**Amendments to the Drawings:**

Attachment: Replacement Sheet (1)  
Annotated Sheet Showing Changes (1)

FIG. 2

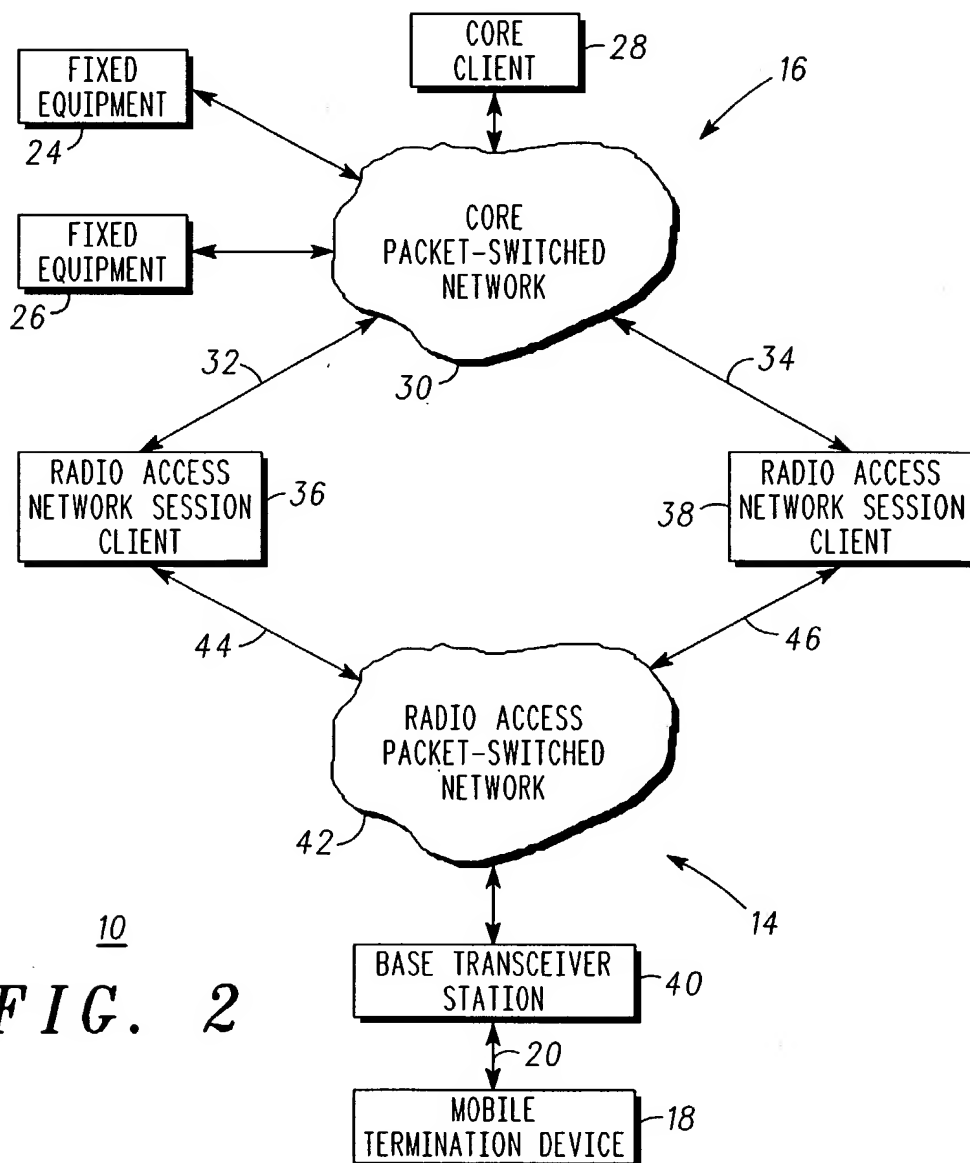
The attached one (1) page of replacement sheet of drawings includes changes to FIG. 2. This replacement drawing sheet, which includes FIGs. 1 and 2, replaces the original drawing sheet including FIGs. 1 and 2. Specifically, in FIG. 2, the text at element 38 has been changed from “access network radio session client” to --radio access network session client--. Support for this change can be found in the specification at, for example, page 3, lines 1-4 (providing that “RSC” stands for radio access network session client) and page 6, lines 24-29 (identifying element 38 as an “RSC”). Consequently, no new matter has been added by this change.
